TRUCK UTILITY LIGHT (TUL) HS TRUCK UTILITY MEDIUM (TUM) HS AND (TUM) AMBULANCE HS

MODIFICATION INSTRUCTIONS AND INDEX

**TRUCK UTILITY LIGHT (TUL) HS
TRUCK UTILITY MEDIUM (TUM) HS
AND (TUM) AMBULANCE HS
MODIFICATION INSTRUCTION No 1**

APPENDIX 1 – CUTTING TEMPLATE

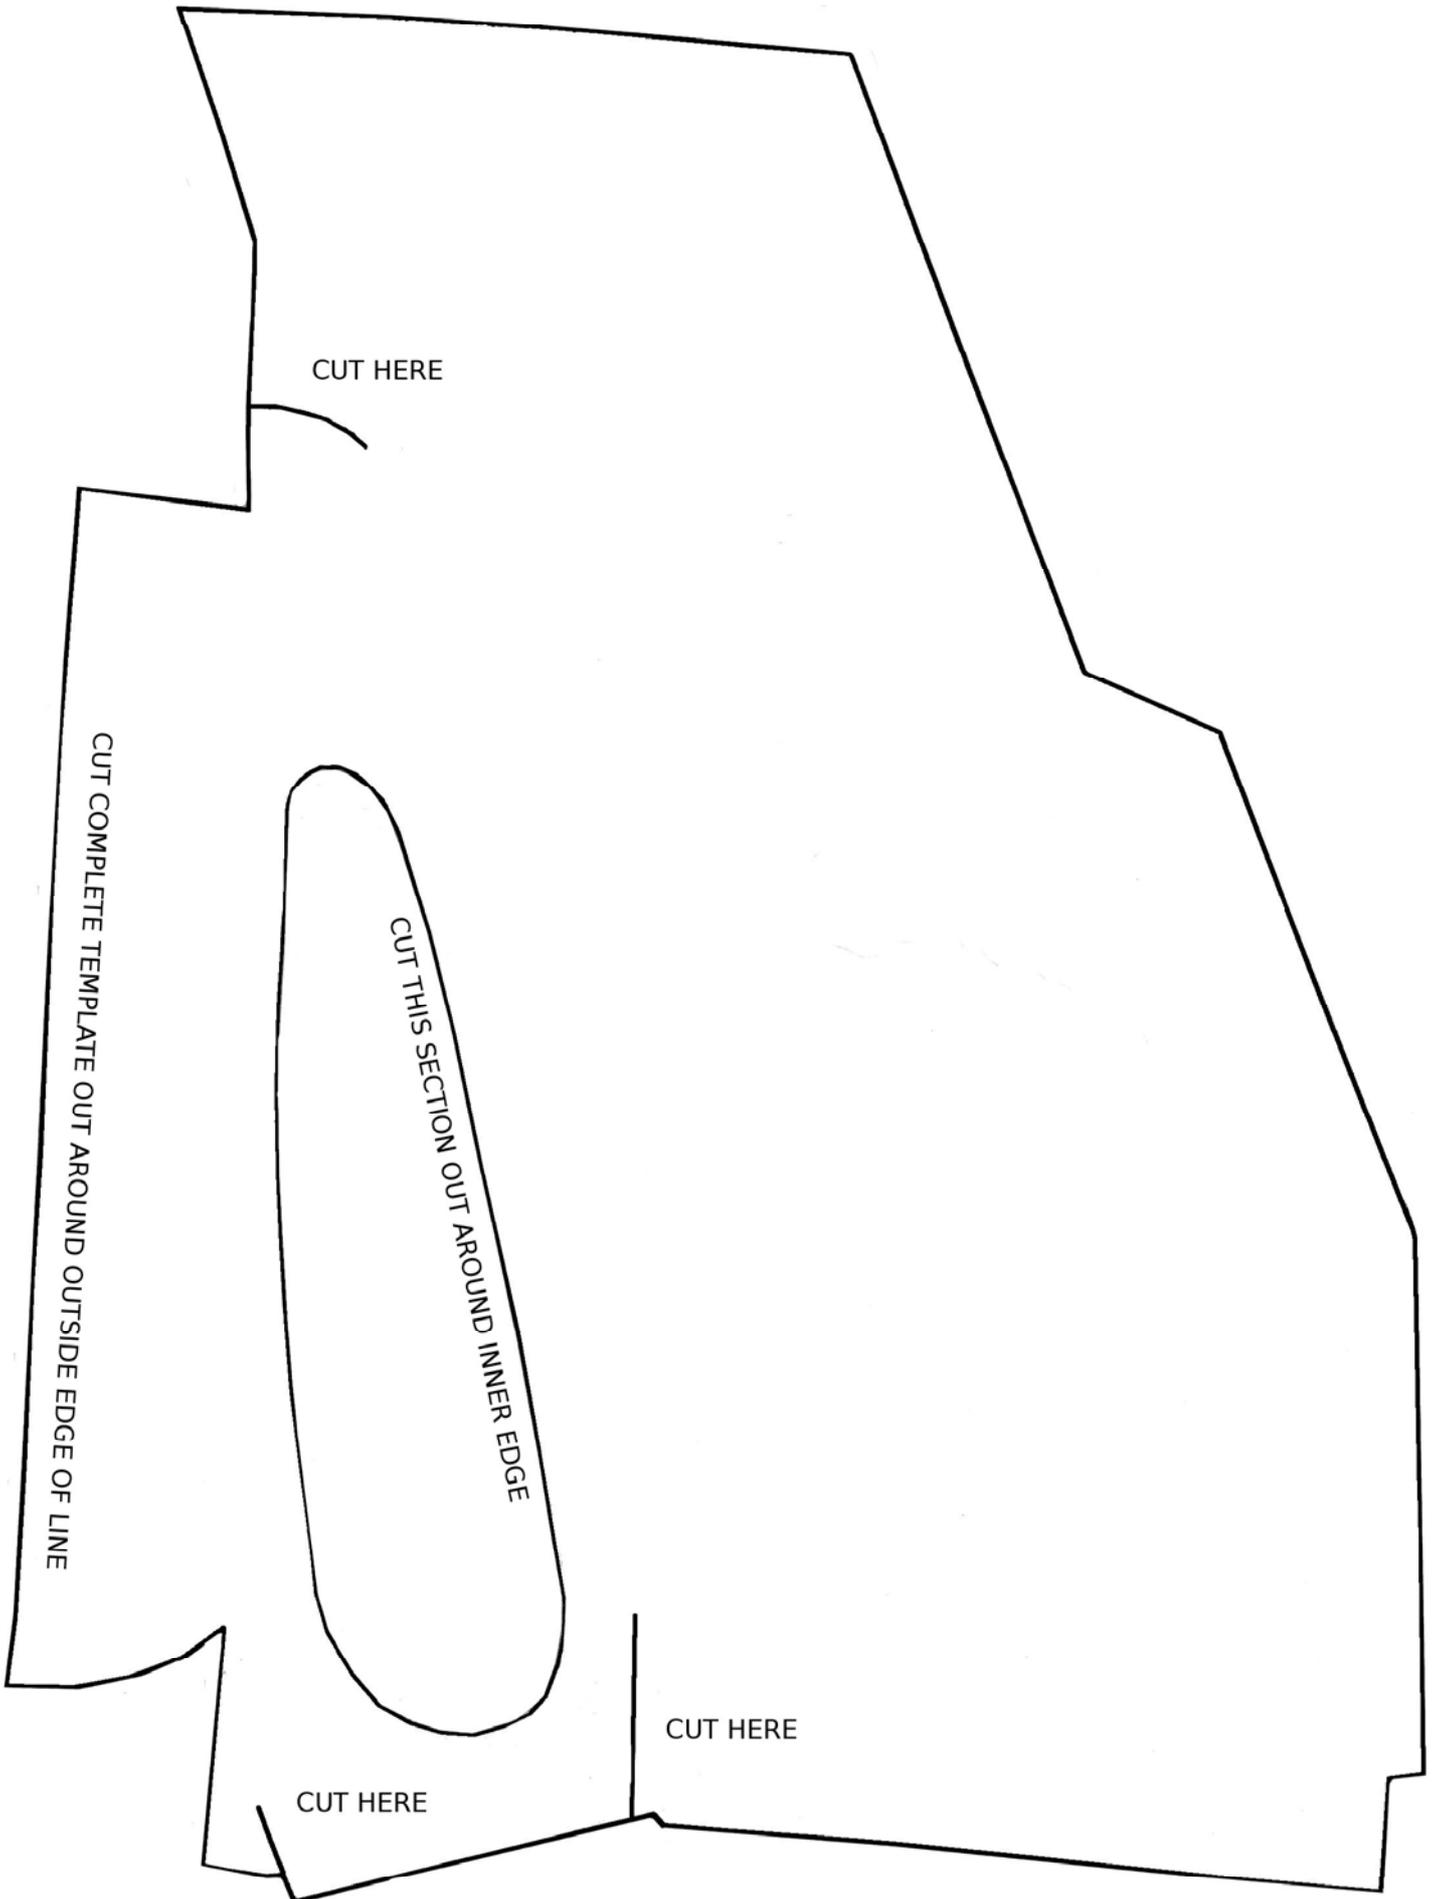
- 9.14.1 Remove the Dexion racking from the B hoop.
- 9.14.2 Modify the cut outs in the upper and lower racking (refer to Fig 19).
- 9.14.3 Fit the Dexion racking to the B hoop (item 1).

Fig 1 Floor drilling and preparation

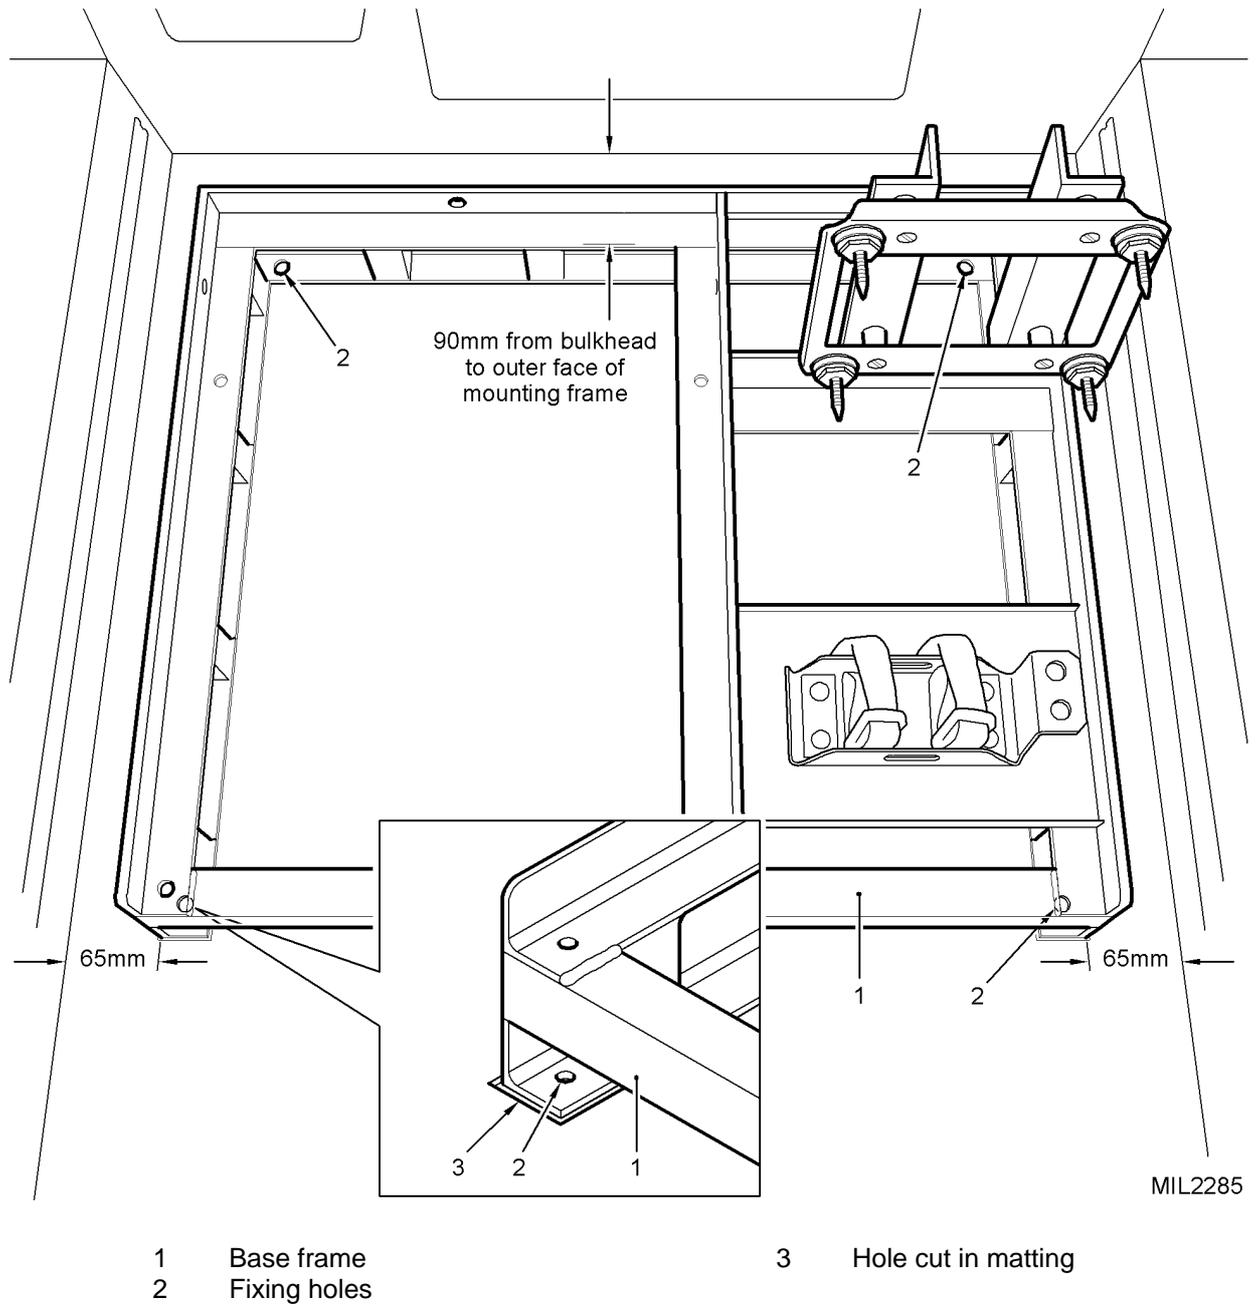
- 9.10 Drill four holes 8.5mm dia and deburr.

Fig 9 Pipework modification

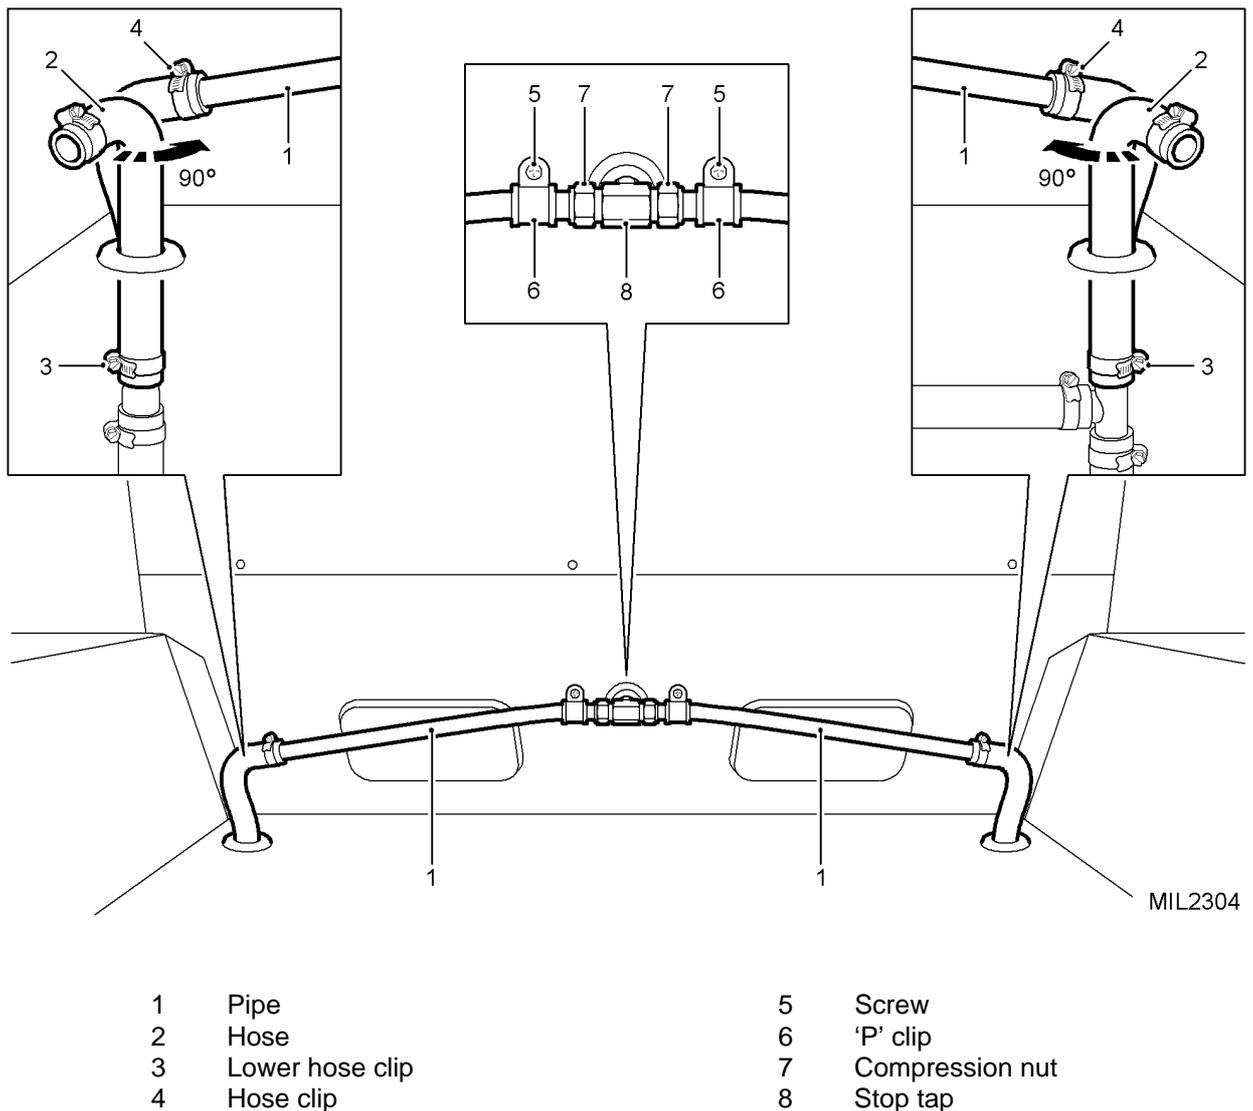
- 10.1 Slacken the lower hose clip securing the hose. (Refer to Fig 9).
- 10.2 Rotate the hose through 90 degrees and tighten lower hose clip.
- 10.3 Repeat Paras 9.1 and 9.2 to the other hose.
- 10.4 Bend pipes to suit installation.
- 10.5 Connect the hoses to the pipes from the stop tap using hose clips.
- 10.6 Check tightness of compression nuts on stop tap.
- 10.7 Check tightness of screws holding 'P' clips.
